11 January 2002

RE: Transmittal – *Response to Comments Document*  
RI/RA and FS Reports – Site Soils and Overburden Ground Water  
Galaxy/Spectron Superfund Site – Elkton, Maryland  
ERM W.O. No. 94907.29

**RESPONSE TO USEPA COMMENTS**  
**Remedial Investigation/Risk Assessment and Feasibility Study Reports**  
**Galaxy/Spectron Superfund Site – Elkton, Maryland**

**Figure 4-5h**  
**Cross-Section H-H'**  
 Galaxy/Spectron Site  
 Site Soils and Overburden  
 Ground Water RI Report  
 Elkton, Maryland

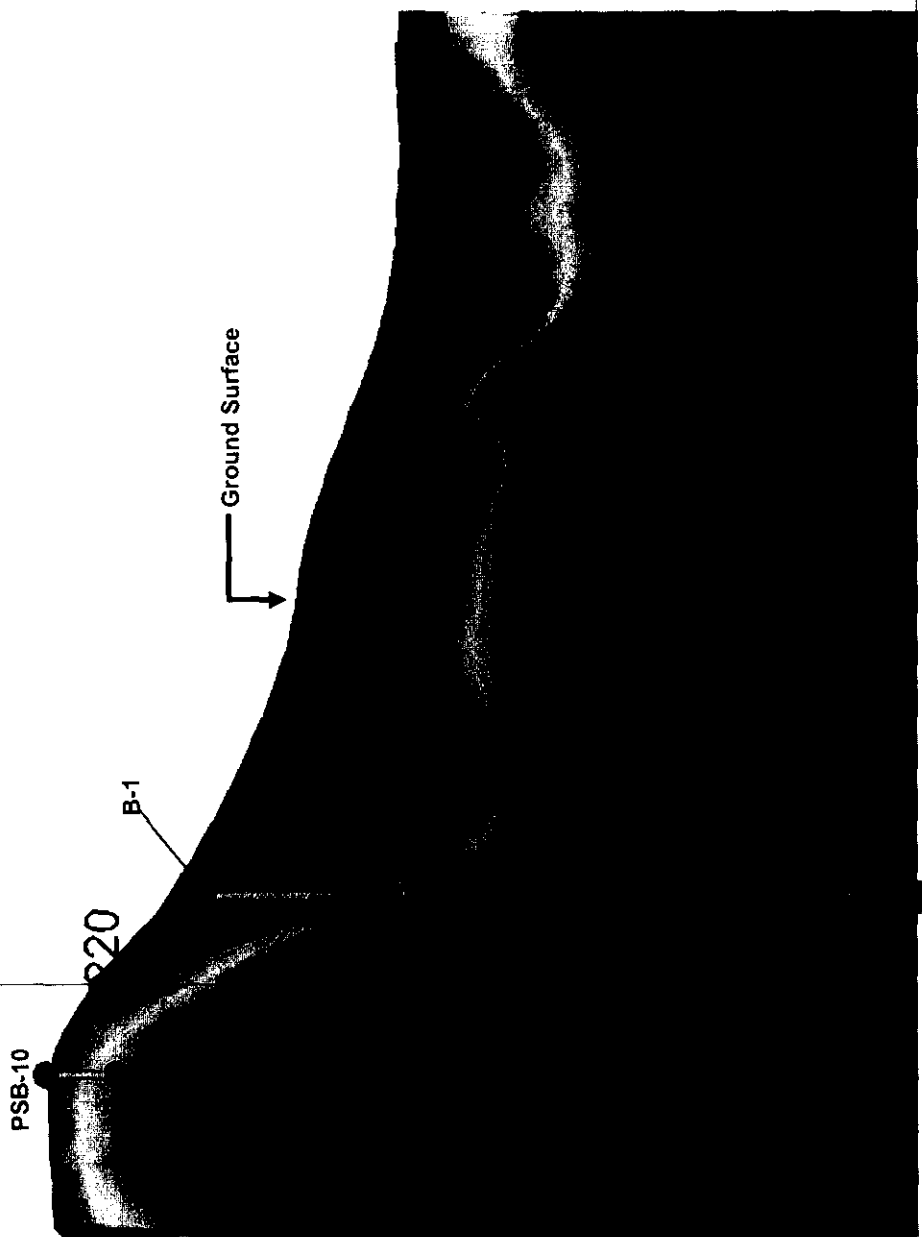
*Page 5-4, 2nd paragraph; page 5-5, 3rd paragraph, last sentence: Please provide a typical cross section of the area being discussed.*

A similar cross section of the former Evaporation Lagoon (Figure 4-5h, attached) is provided and will also be included in the revised RI report.

**Figure 5-4**  
**A-A' Cross-Section**  
**Soil PCE Concentrations Above RBC of 12 ppm**  
 Galaxy/Spectron Site  
 Site Soils and Overburden Ground Water RI Report  
 Elkton, Maryland

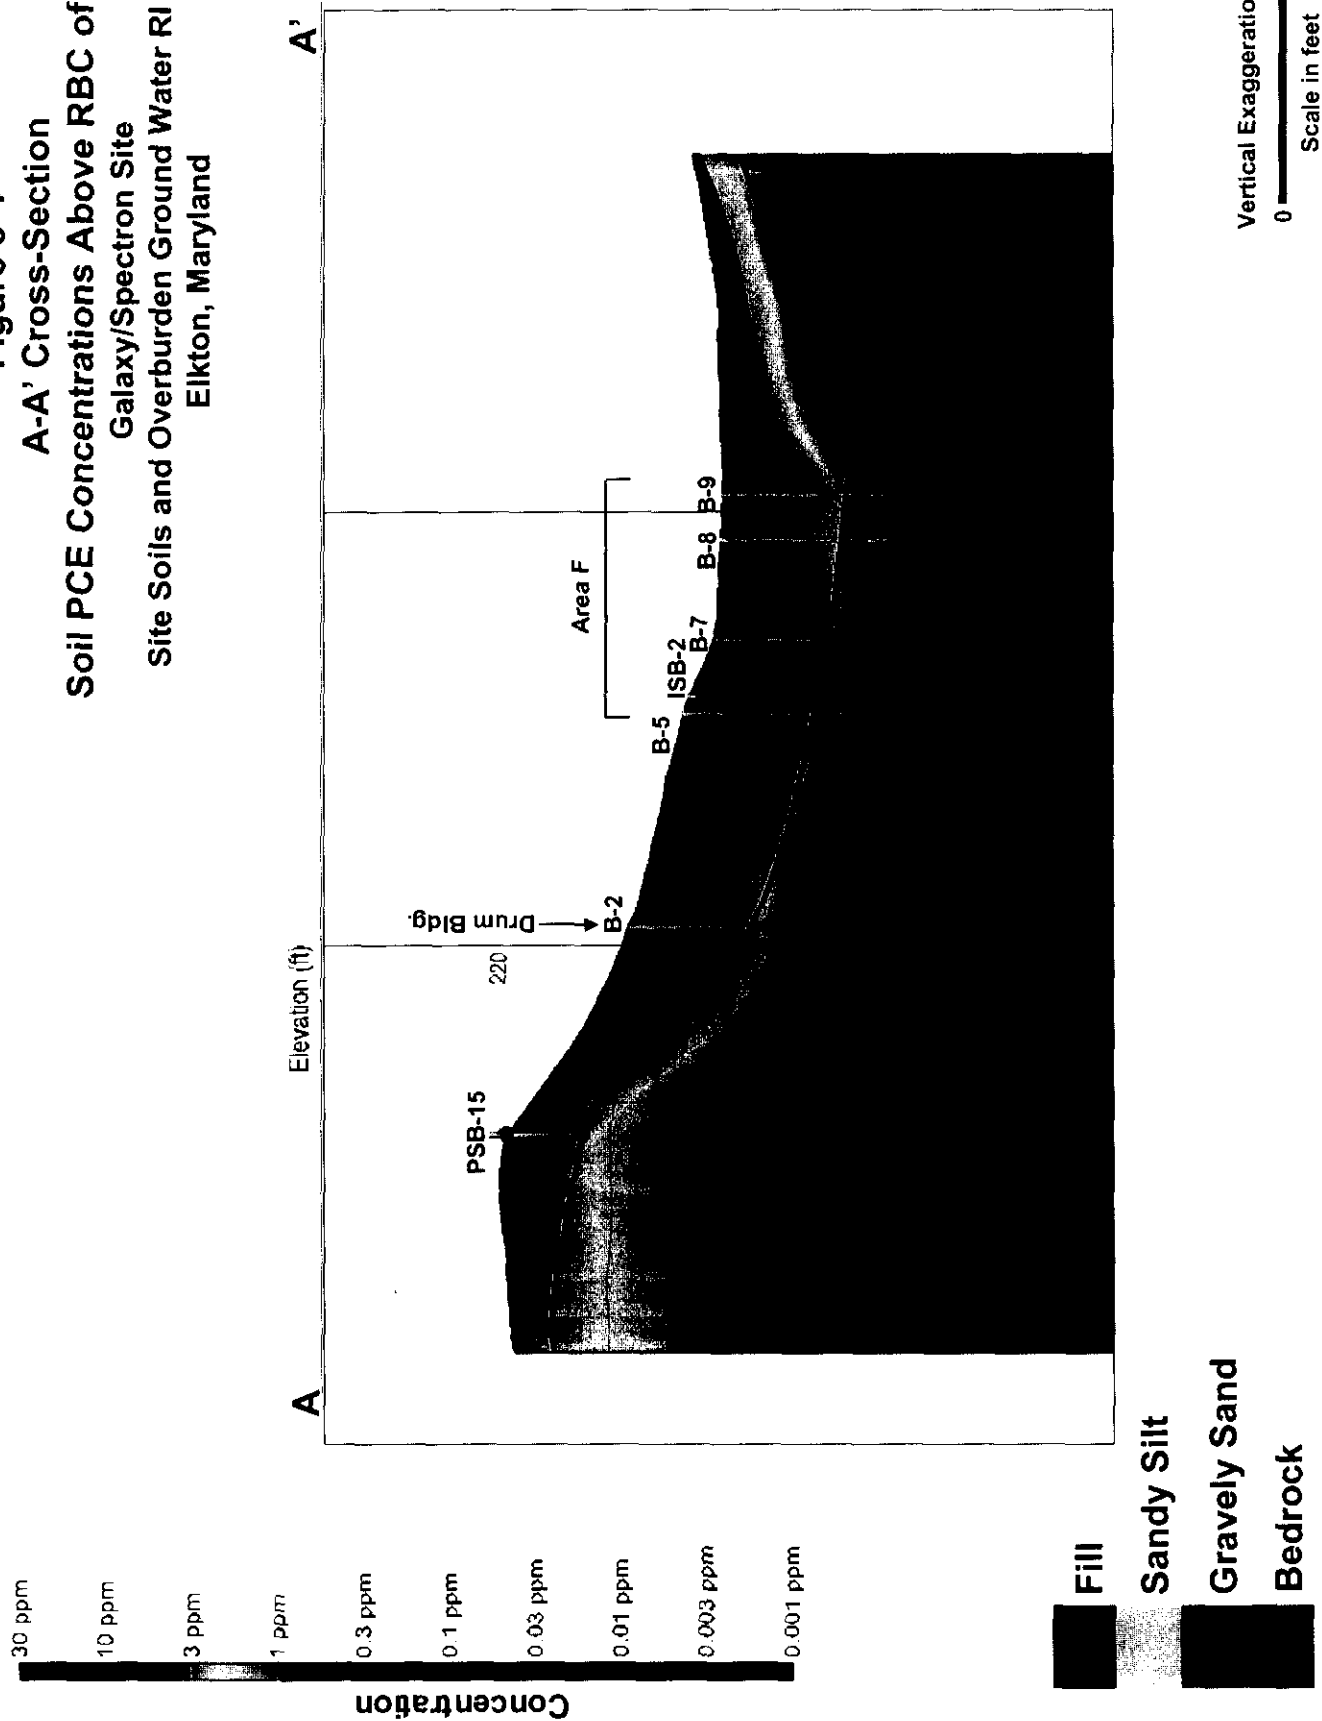
*Figures 5-4, 5-6, 5-8, 5-10 should show only those borings/geoprobe locations that are within 25 ft. of the cross-section. The ground elevation should be shown through the cross-section. Although this information is presented in various formats in other figures, these cross-sections should include stratigraphy and shallow ground water elevation. It is difficult to interpret these cross-sections in order to develop appropriate contaminant pathway models. It is important to discuss and present in clear graphical format in the RI the nature and extent of the contamination. The figures presented are very helpful in this analysis, but a graphic presenting the contamination data with its relationship to the ground surface and shallow ground water is needed. Specifically if the VOC contamination in the soils is primarily below the shallow ground water depth, than the source and pathway of shallow ground water contamination would be different if the higher concentrations are in the vadose zone. This type of discussion and presentation is needed in the RI in order to evaluate the applicable alternatives in the Feasibility Study. The report has not presented a comprehensive analysis of site data to support the statement that 'additional containment, removal and/or treatment options for overburden ground water beyond continuing to operate the Creek Liner to be warranted.' There are very high contaminant concentrations in the overburden aquifer and soils. These high concentrations will continue one specific area where extent of contamination is in question is to the far Northwest of the site. Logs indicate contamination at depth with a field PID meter but a sample at this depth was not taken to the lab for analysis (See sampling log for PSB-12 and 14).*

Figures 5-4, 5-6, 5-8 and 5-10 (attached) were revised to outline the source areas. Additionally, new figures 5-12a and b and 5-18a through 5-21b (attached) that depict ground water concentrations also outline the source areas.
